Approved Section 4.55 (.....2.....) Modification Application

Project
BARANGAROO STAGE 1B
PUBLIC DOMAIN
Modification S4.55

Drawing Title
**HICKSON PARK WEST ENTRY
DETAIL PLAN - NO TREES**
Drawn
SS

Drawing Title
WULUGUL WALK
MASTERPLAN - NO TREES

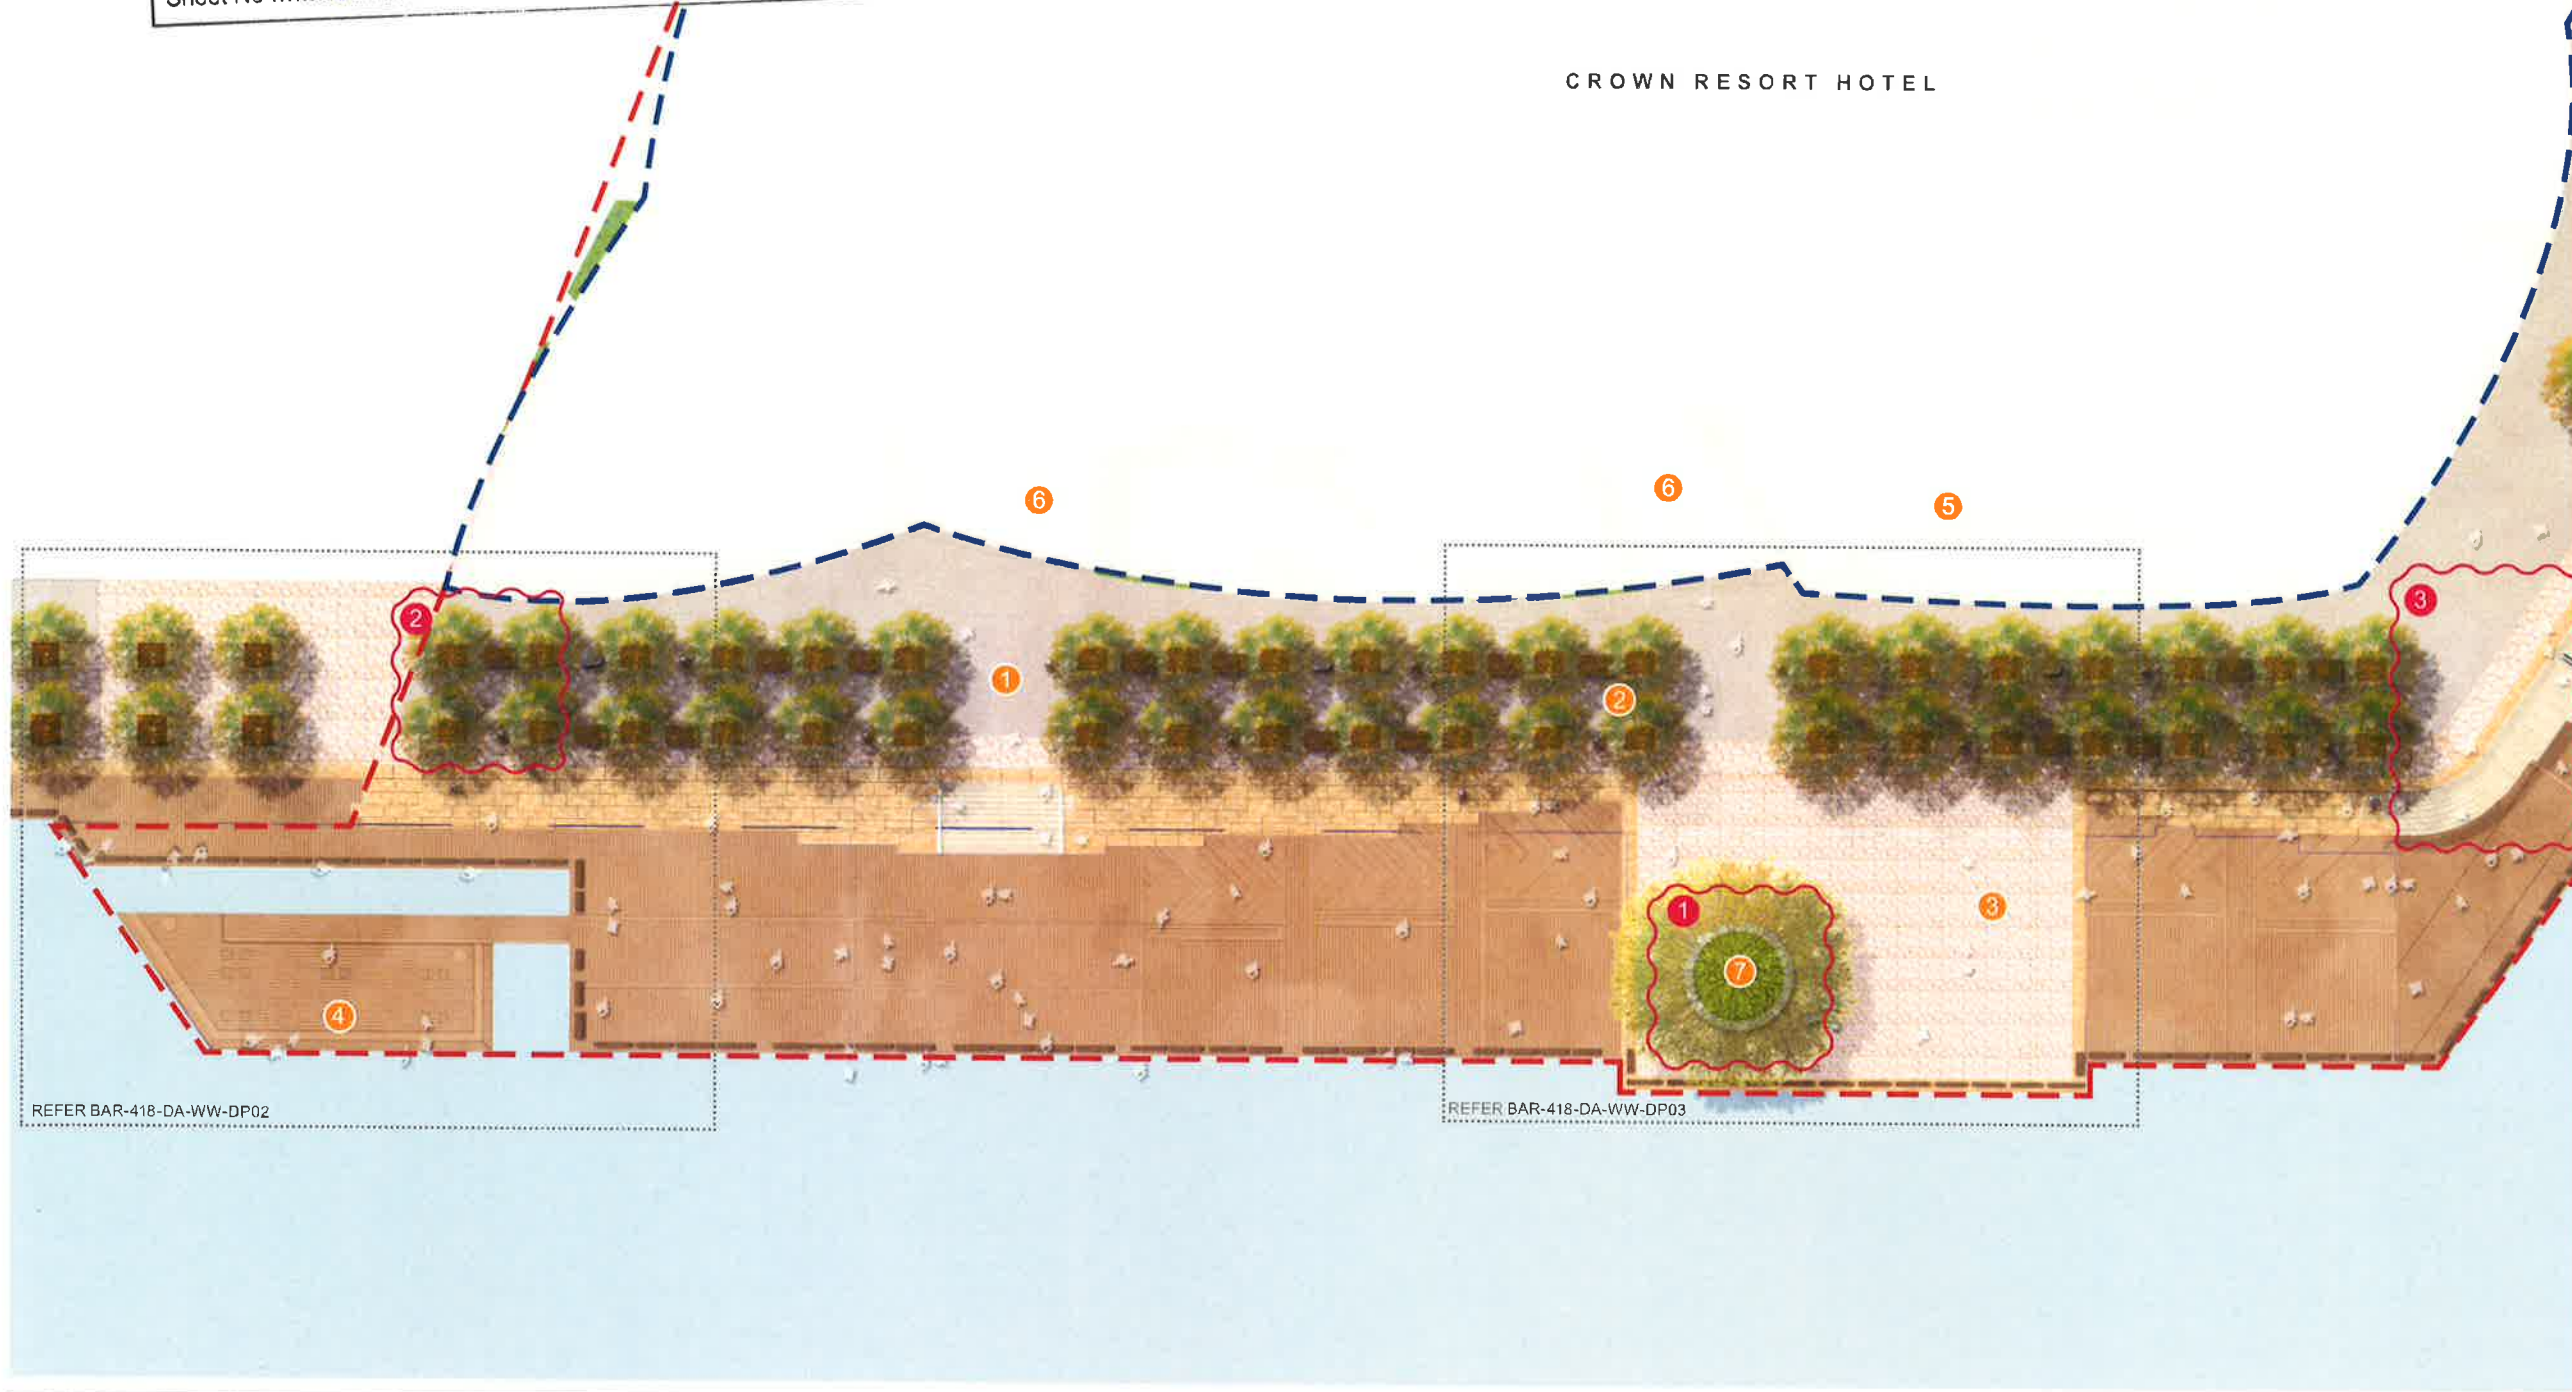
- Amendment cloud
- 1 Remove timber top for Sprit of Tasmania loading dock raised planter seating
- 2 No porphyry paving at Northern end of Wulugul walk
- 3 Stone stairs changed to concrete
- 4 Additional smart pole

Drawing Title
WULUGUL WALK BOARDWALK
DETAIL PLAN - NO TREES

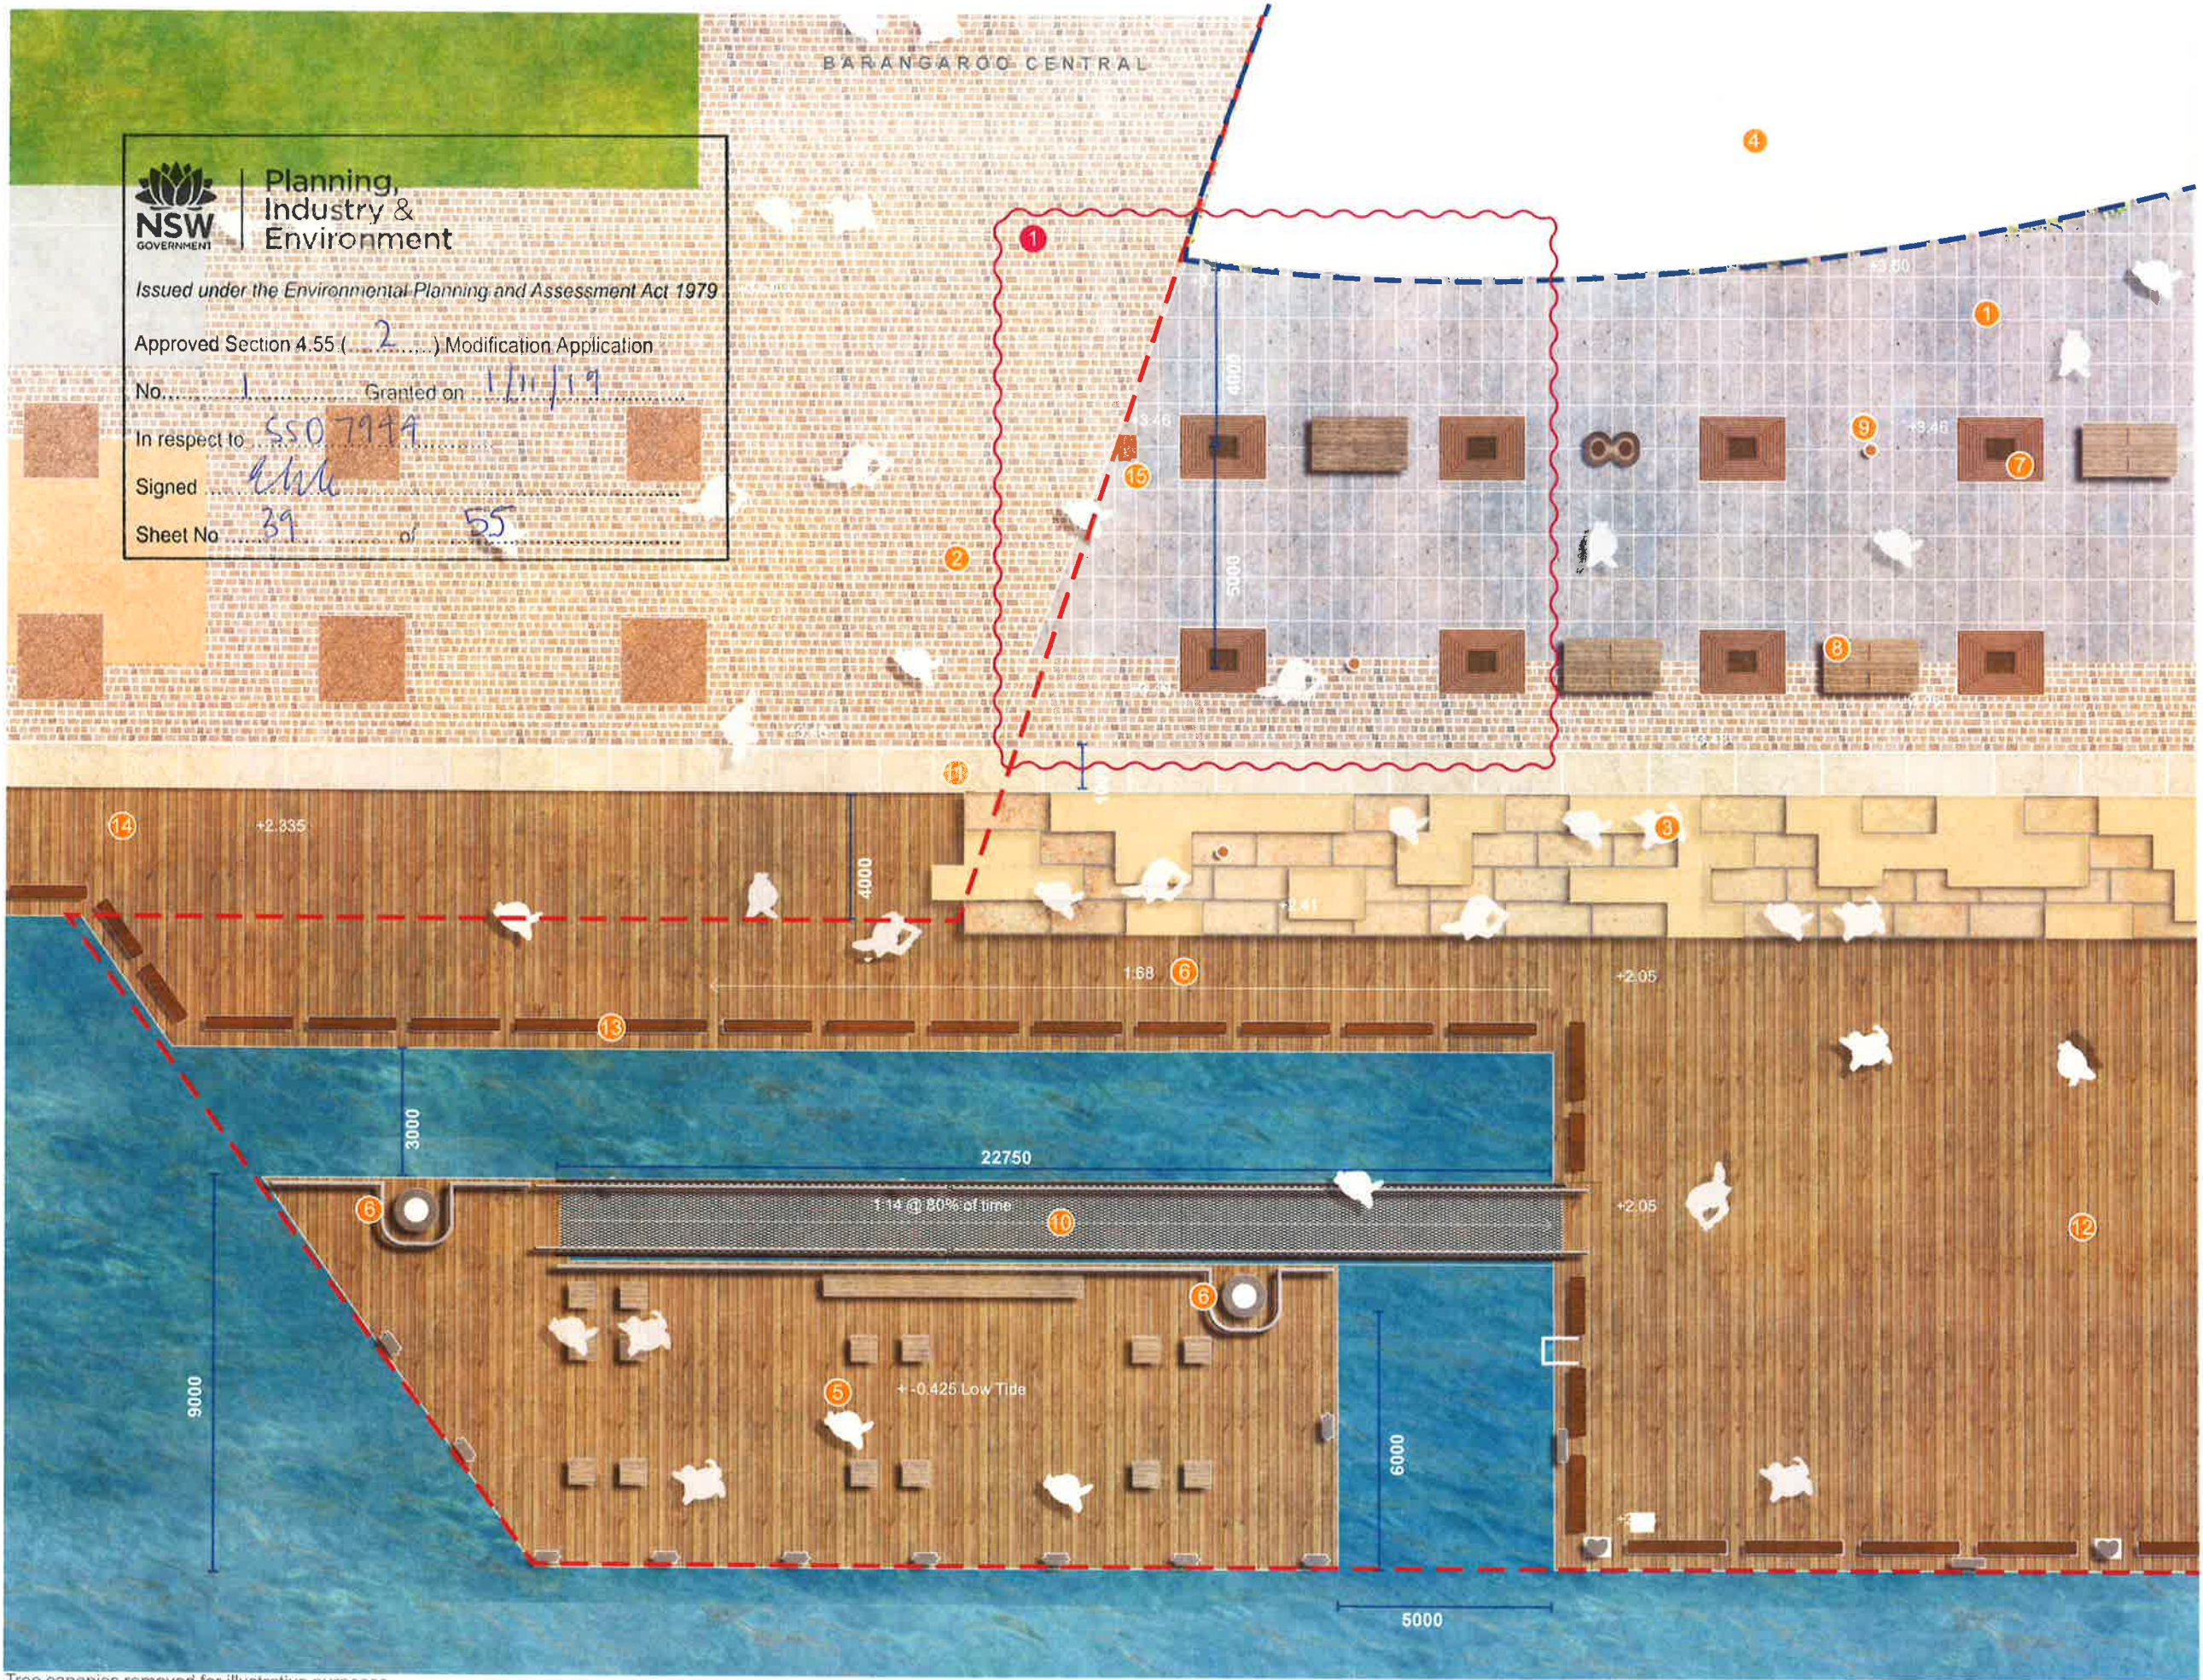
- Amendment cloud
- 1 No porphyry paving at Northern end of Wulugul walk
